**AGENDA
CITY OF BELTON
PLANNING COMMISSION
MEETING & PUBLIC HEARING
MONDAY, NOVEMBER 7, 2016 - 6:00 P.M.
CITY HALL ANNEX, 520 MAIN STREET**

FINAL DEVELOPMENT PLAN
LOT 4, BELTON GATEWAY ADDITION UNIT NO. 2

CASE #FDP16-0071

FINAL DEVELOPMENT PLAN
BLOCK 1, BELTON GATEWAY ADDITION UNIT NO. 2

Final Development Plan

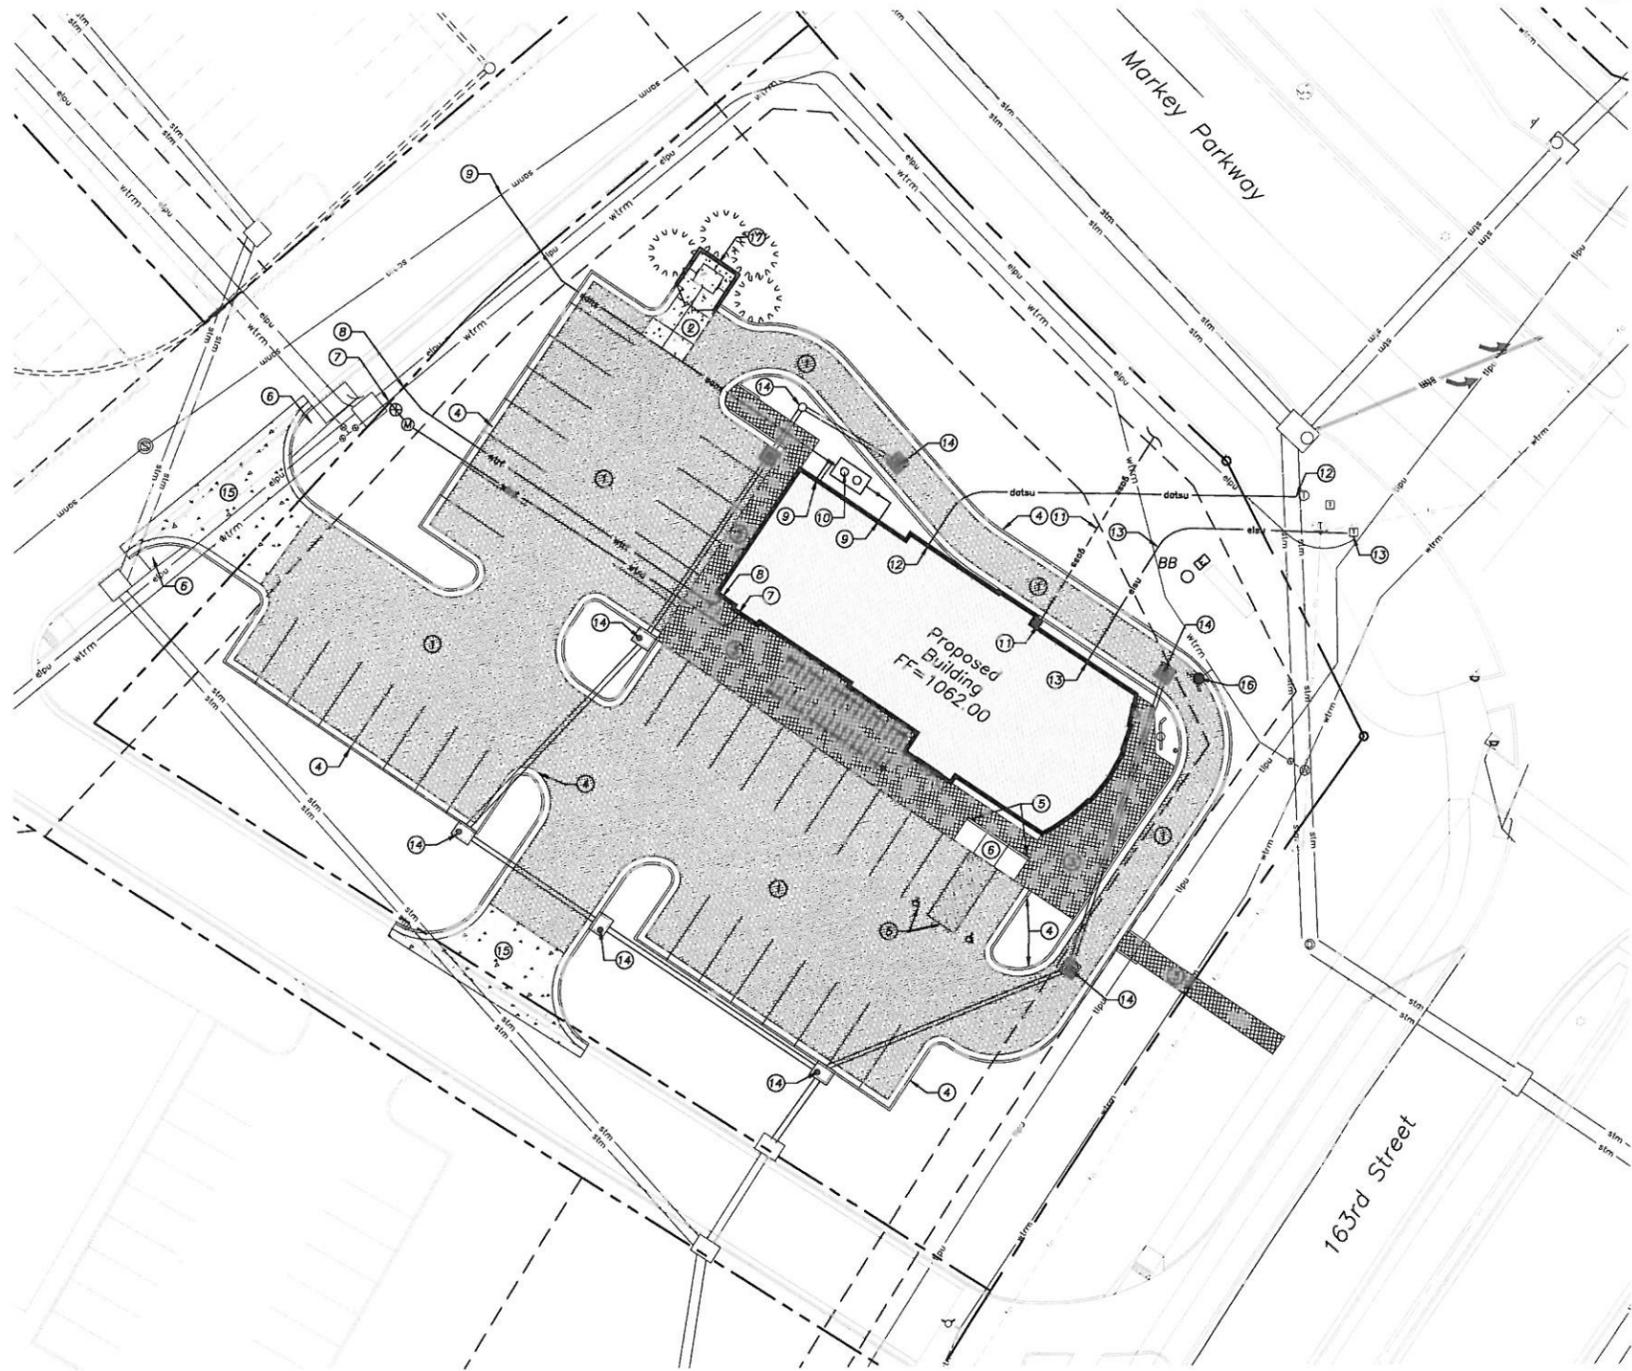
1. Participation in the Markey Regional Detention program in lieu of on-site detention requires execution by the developer and City of the standard "Agreement Regarding the Use of the Markey Regional Detention Facility In Lieu of Providing On Site or Other Private Detention"
2. Provide backflow vault and preventer for private fire line if length of line exceeds 100 feet.
3. Construct 10-foot walking trail on Markey Parkway frontage per City standards.
4. Revise plans to include two hydrants per plan mark-ups emailed by Dave Olson with Christie Development on October 7, 2016.

Final Site Development Plan

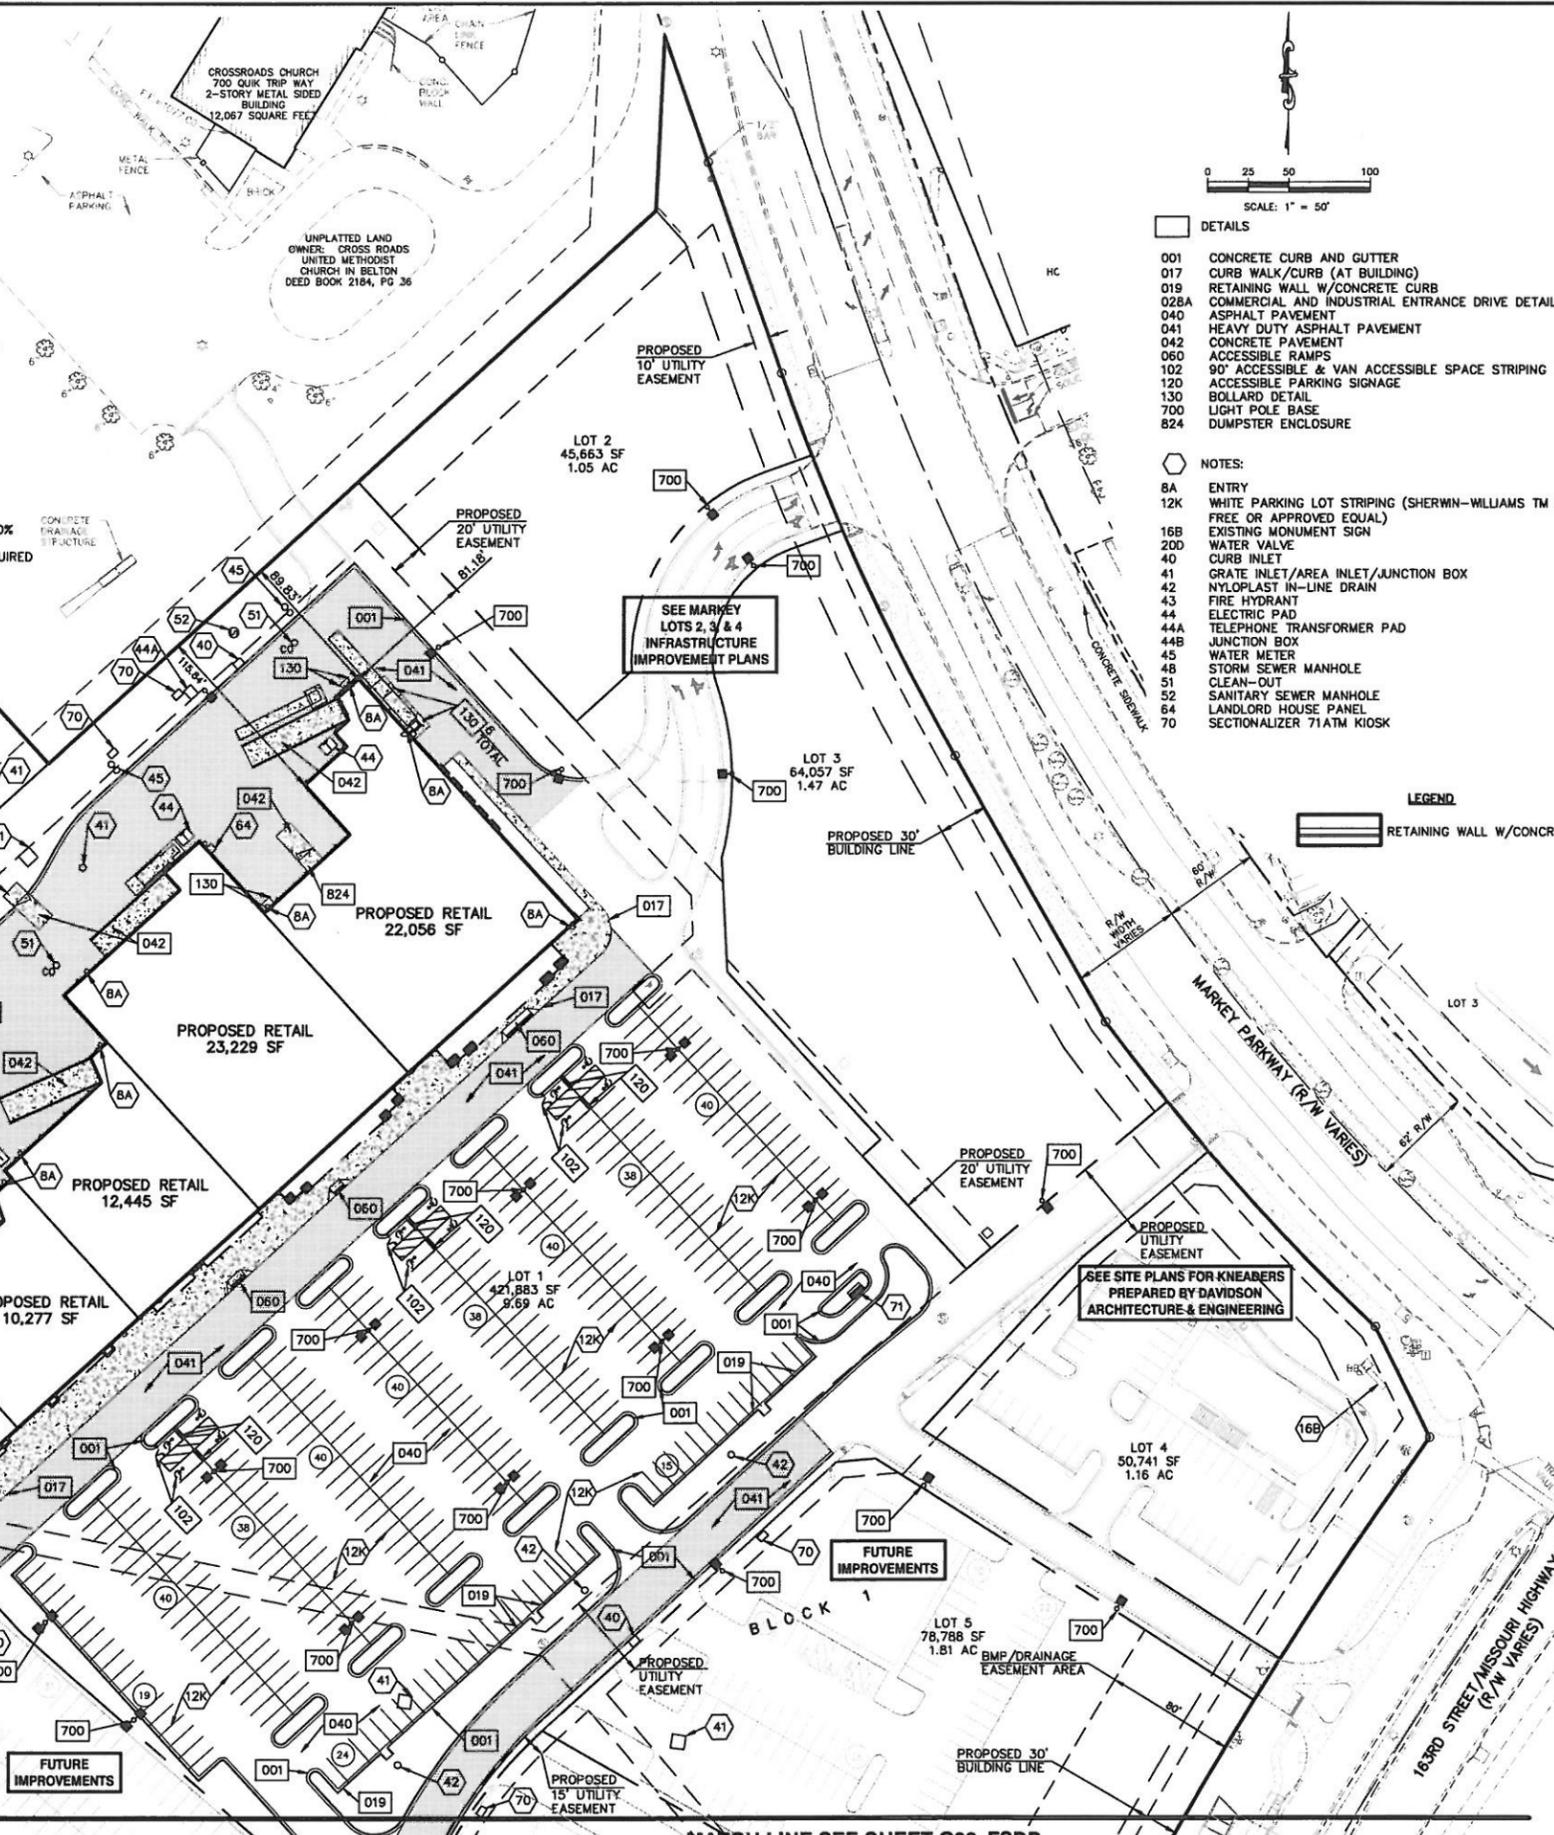
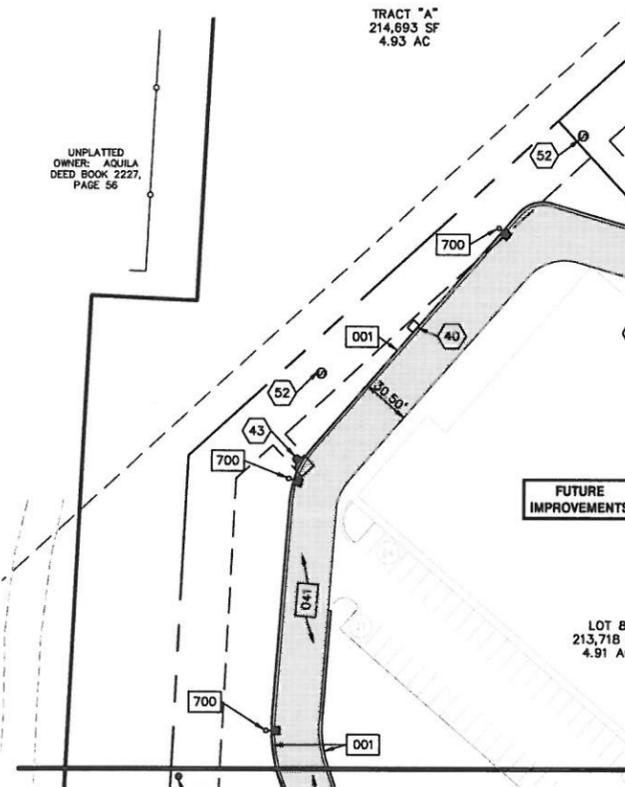
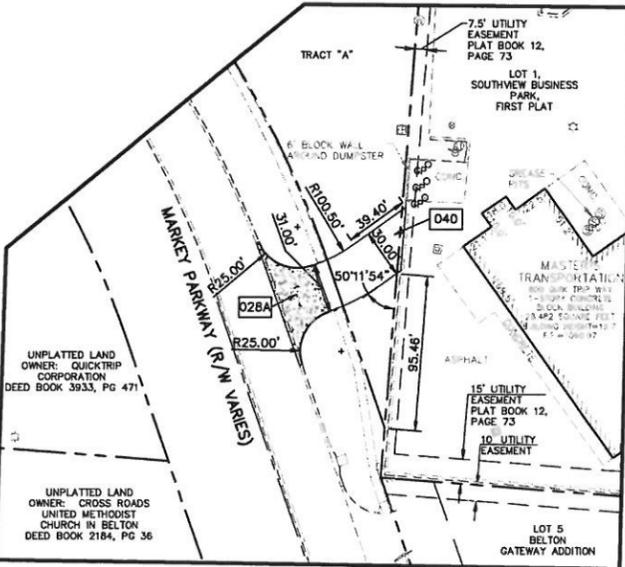
Provide backflow vaults and preventers for private fire lines if length of dead-end line exceeds 100 feet. Backflow preventer can be inside building if length of dead-end line is less than 100 feet;

Clarify signage such as stop signs for internal traffic movements;
